SPARC® Enterprise M8000/M9000 Servers Product Notes

For XCP version 1070

Updates of the SPARC Enterprise M8000/M9000 Servers Site Planning Guide

FIGURE 1-18 SPARC Enterprise M8000 Server + Power Cabinet Bottom View

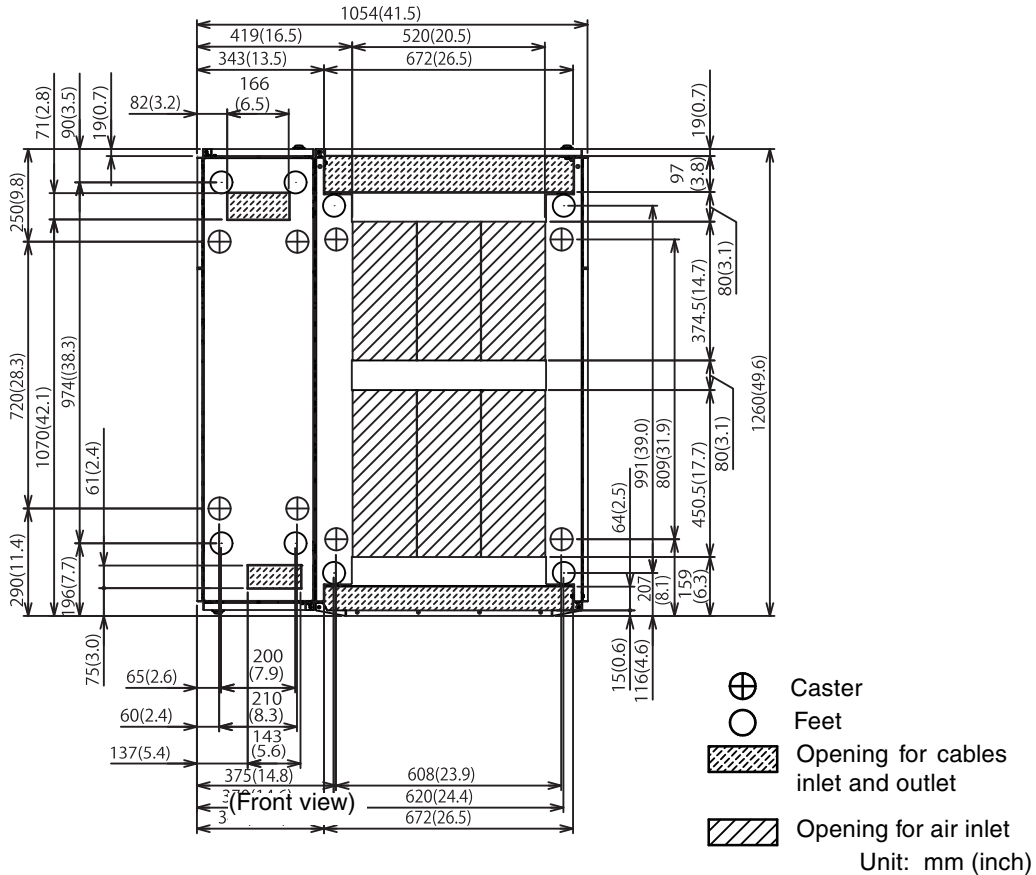
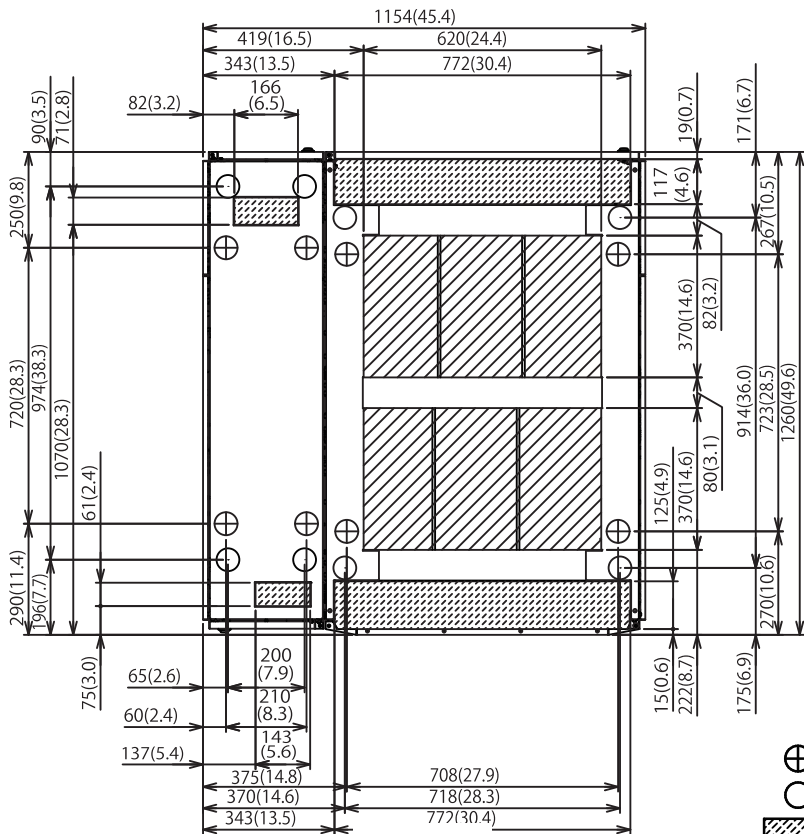
This is to correct the description in Section 1.2.2.2, "Bottom View of the Components", FIGURE 1-18 SPARC Enterprise M8000 Server + Power Cabinet Bottom View and FIGURE 1-20 SPARC Enterprise M9000 Server (Base Cabinet) + Power Cabinet Bottom View. The correct figures are as follows:
